May 21, 2004
LIC-04-0045

**SUBJECT: Fort Calhoun Station Unit No. 1 License Amendment Request (LAR),
"Trisodium Phosphate Volume"**

**Fort Calhoun Station's Evaluation
for
Amendment of Operating License**

Figure 2-3

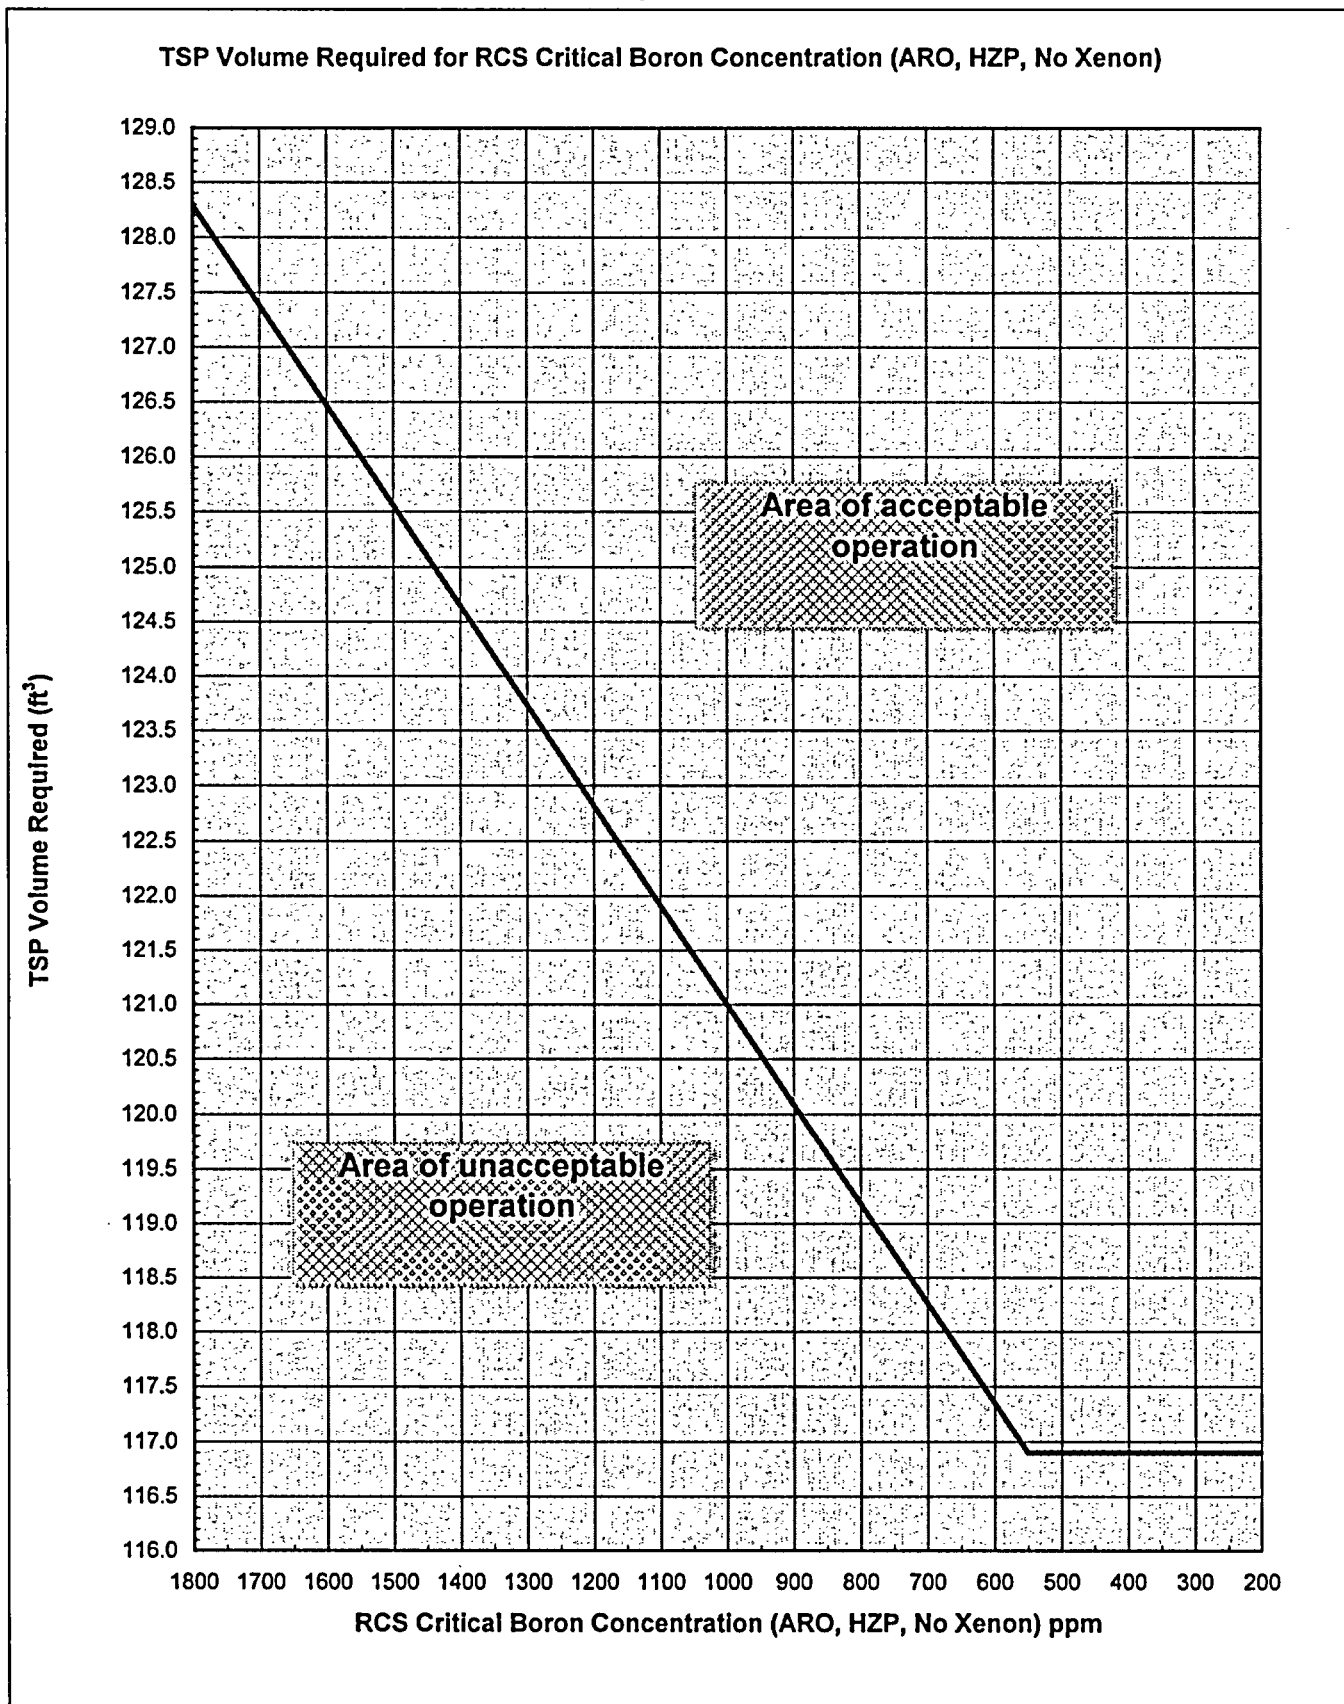
The proposed revision incorporates a new figure (Figure 2-3) that shows the minimum required volume of TSP versus reactor coolant system HZP CBC over the operating cycle. The TSP volume requirements outlined in Figure 2-3 bound expected HZP CBC for any operating cycle. Based on historical data, the beginning of cycle HZP CBC is bounded by 1800 ppm and the EOC is bounded by 550 ppm. Thus, these points were chosen to generate the curve. The end of cycle HZP CBC could be less than 550 ppm so the curve is extended as a horizontal line at this point. Thus, the minimum required volume of TSP does not decrease below that required at a HZP CBC level of 550 ppm. It is proposed to revise TS 2.3(4) and TS 3.6(2)d.(i) to require compliance with Figure 2-3 during Operating Modes 1 and 2. Corresponding Basis changes are also proposed.

The proposed amendment deletes the term “dodecahydrate” from TS 2.3(4) and revises the Basis of TS 2.3 to require TSP that is of the hydrated form (45 - 57% moisture). These changes make TS 2.3(4) and its Basis consistent with NUREG-1432, Rev. 2, “Standard Technical Specifications Combustion Engineering Plants,” which does not require a specific type of TSP. TS 2.3(4) also requires adherence to a new figure (Figure 2-3) that graphs the minimum required volume of TSP versus HZP CBC over the operating cycle. The TSP volume requirements outlined in Figure 2-3 bound expected HZP CBC for any operating cycle. Based on historical data, the beginning of cycle HZP CBC is bounded by 1800 ppm and EOC is bounded by 550 ppm. Thus these points were chosen to generate the curve.

The end of cycle HZP CBC could be less than 550 ppm so the curve is extended as a horizontal line at this point so that the volume of TSP required by TS 2.3(4) cannot be less than the amount required at a HZP CBC value of 550 ppm. The surveillance requirement of TS 3.6(2)d.(i) verifies that the volume of TSP is in compliance with Figure 2-3. Corresponding Basis changes to TS 3.6 are also proposed. The proposed changes are described below. A markup and clean copy of the TS pages are included in Attachments 2 and 3 respectively.

A new Figure (Figure 2-3) is proposed for TS 2.3 to show the areas of acceptable and unacceptable operation for the volume of TSP required over the operating cycle versus HZP CBC.

OPPD's engineering analysis determined that compliance with Figure 2-3 will continue to provide a neutral or very slightly basic pH in the containment sump post LOCA. While the end of cycle HZP CBC could be somewhat less than 550 ppm, the allowable volume of TSP is not reduced below that required at 550 ppm as indicated by the horizontal line on Figure 2-3.

During operating Modes 1 and 2, the TSP baskets shall contain a volume of active TSP that is within the area of acceptable operation shown in Figure 2-3.

A refueling frequency shall be utilized to visually determine that the volume of TSP contained in the TSP baskets is within the area of acceptable operation based on the TSP volume required by Figure 2-3. A measured value or the Technical Data Book (TDB) II, "Reactivity Curves" may be used to obtain a hot zero power (HZP) critical boron concentration (CBC). The "as found" volume of TSP must be within the area of acceptable operation of Figure 2-3 using this HZP CBC value. Prior to exiting the refueling outage, another visual TSP volume determination is performed to ensure that the "as-left" volume of TSP contained in the baskets is $\geq 128.3 \text{ ft}^3$. This requirement ensures that there is an adequate quantity of TSP to adjust the pH of the post-LOCA sump solution to a value ≥ 7.0 for HZP CBC up to 1800 ppm.
